SUBJECT: RESPONSE TO 1<sup>ST</sup> PLANCHECK COMMENTS ON THE DRAFT MASTER MAINTENANCE PROGRAM (MMP) MAP 70 AND 76 AUBURN CREEK CHANNEL INDIVIDUAL WATER QUALITY ASSESSMENT (IWQA) REPORT DATED MARCH 30, 2017 (RICK ENGINEERING COMPANY JOB NUMBER 17204-L)

## INDIVIDUAL WATER QUALITY ASSESSMENT REPORT

**Site Name/Facility:** Auburn Creek Channel  
**Master Program Map No.:** Maps 70 and 76  
**Date:** March 30, 2017; Revised April 28, 2017  
**Civil Engineer (name, company, phone number):** Jayne Janda-Timba  
Rick Engineering Company  
5620 Friars Road  
San Diego, California 92110  
(619) 688-1448  
**Register Civil Engineer Number & Expiration Date (place stamp here):** RCE # 70649  
Exp. 06/2017

**Figure 3 - IWQA Limits of Channel Maintenance for Auburn Creek Channel MMP Maps 70 and 76**

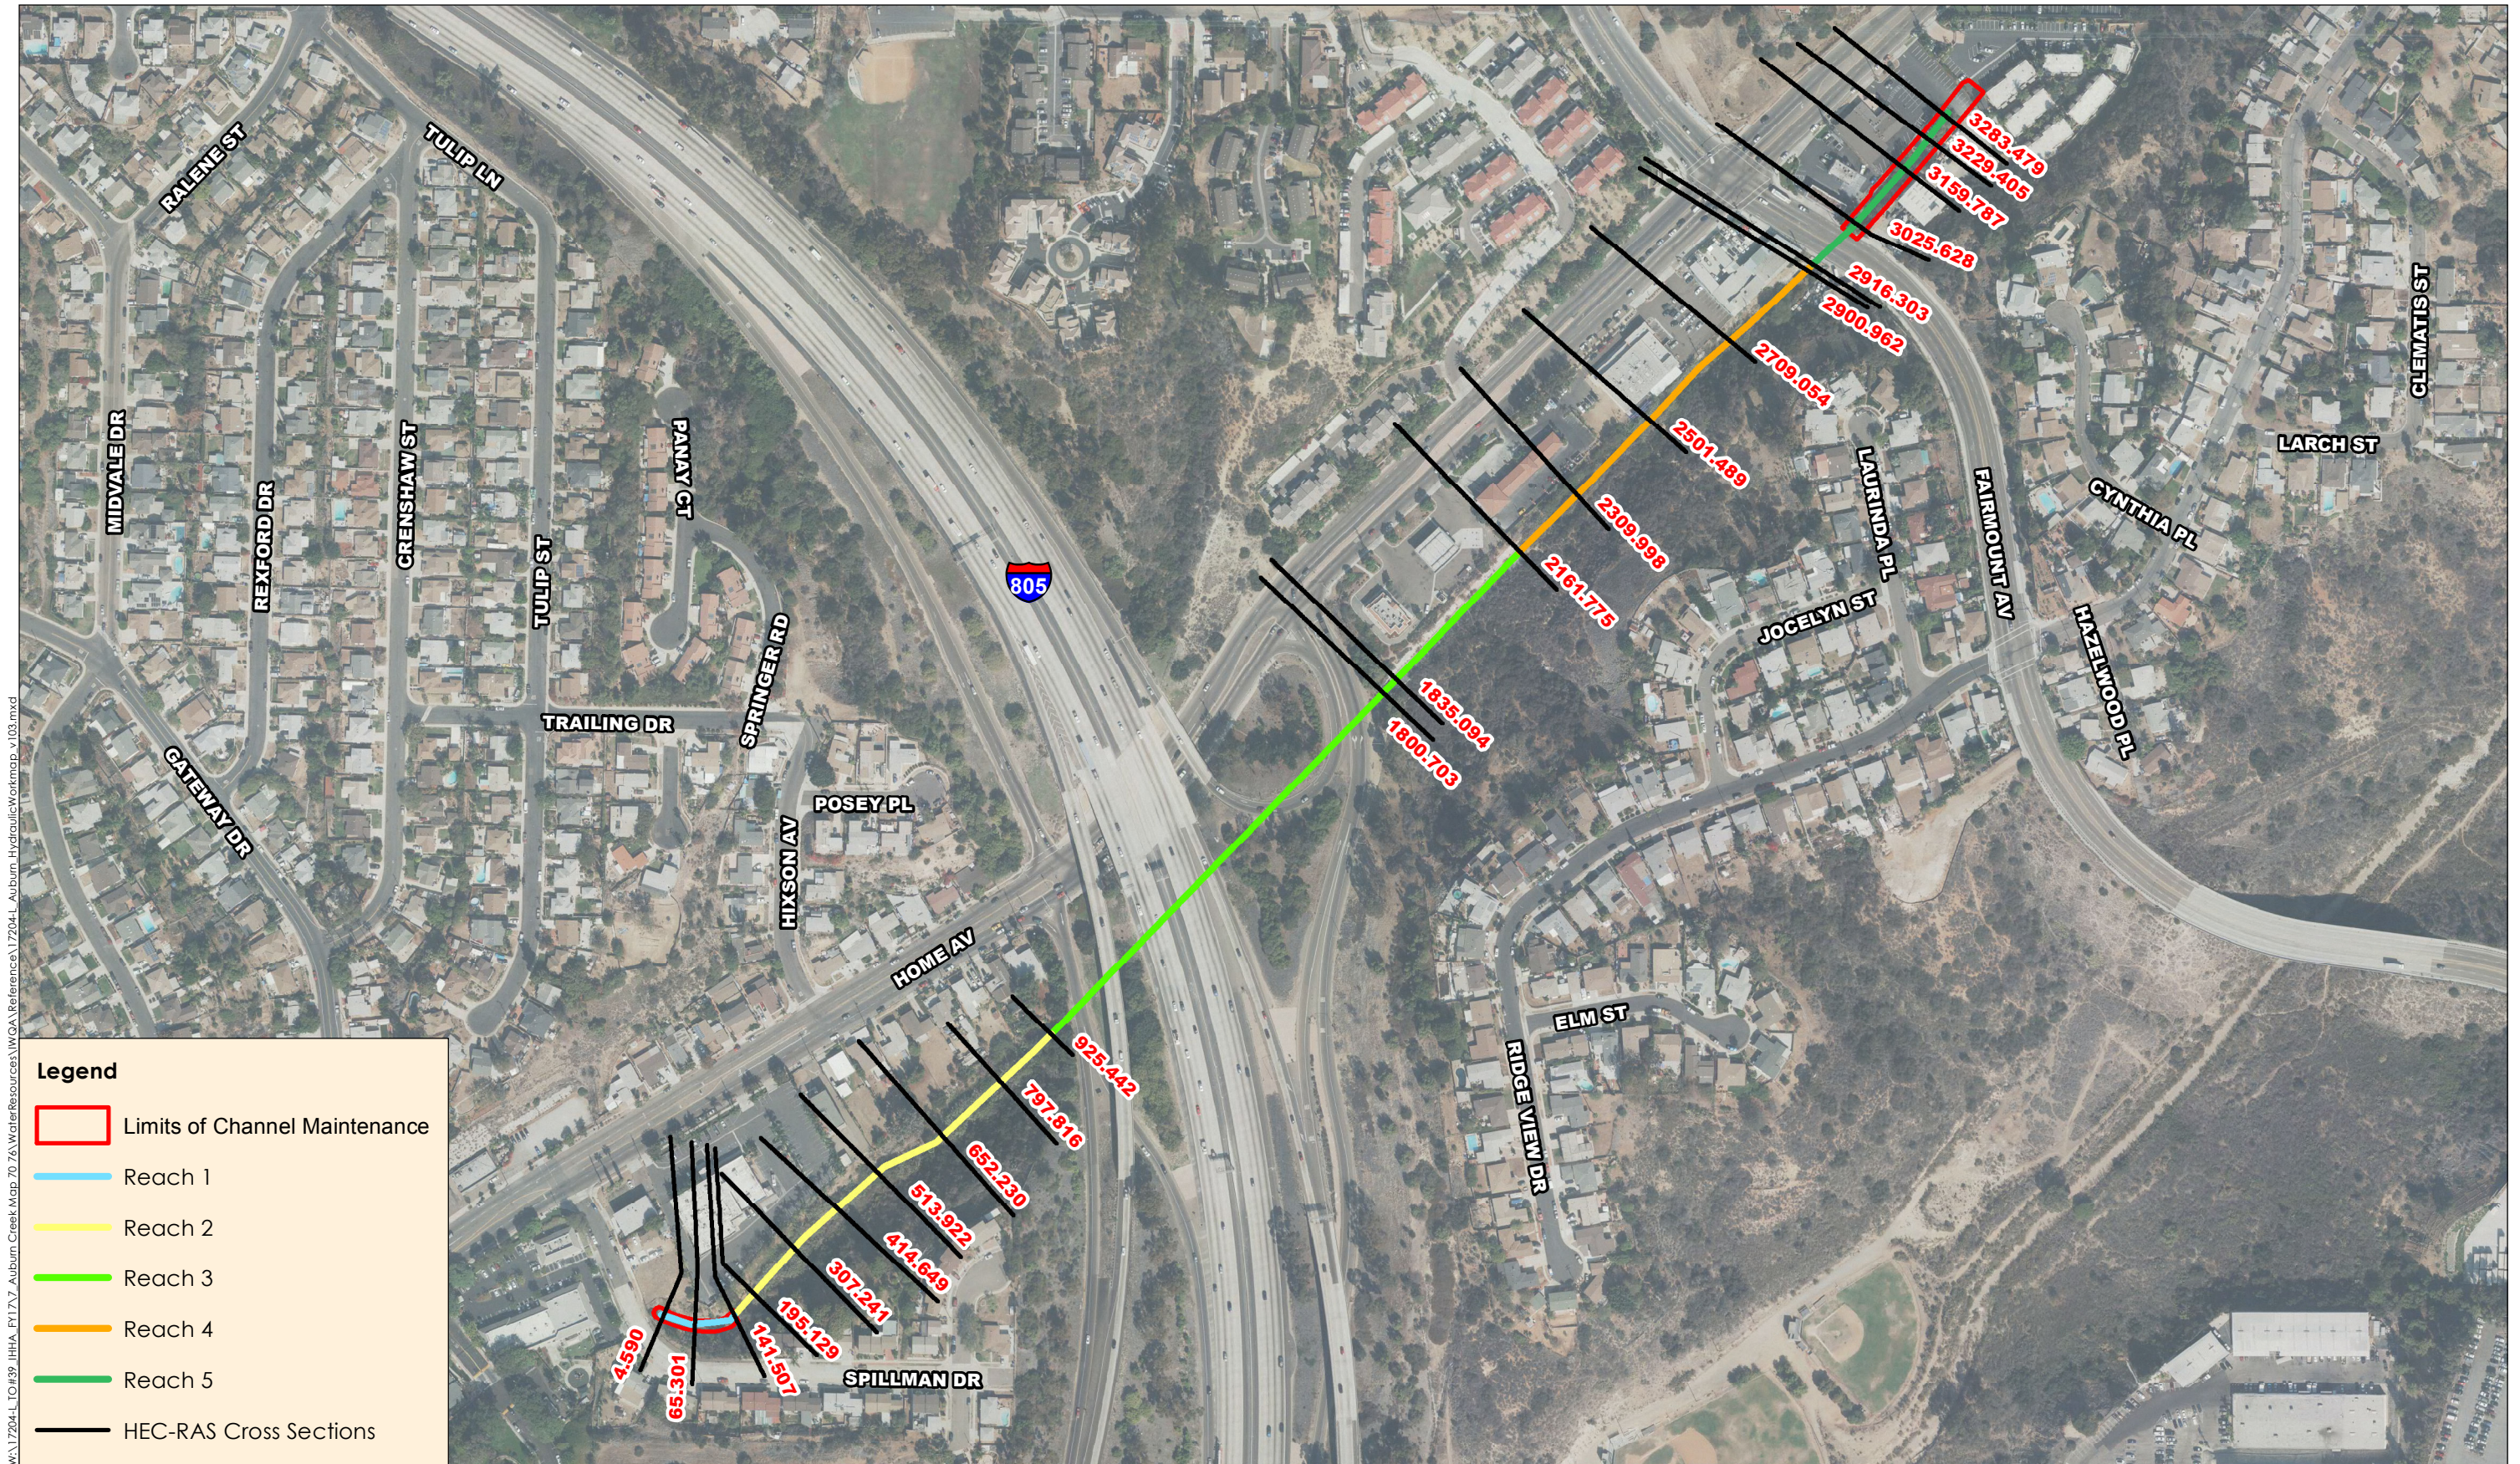
Pursuant to the email dated April 27, 2017 from the City of San Diego, there were no comments to the Auburn Creek IWQA. However, Figure 3 – Limits of Channel Maintenance for Auburn Creek Channel MMP Maps 70 and 76, Figure 4 – Hydraulic Workmap, and Figure 5 – Photo Locations Map have each been revised to remove the culvert under Fairmont Avenue from the limits of channel maintenance.
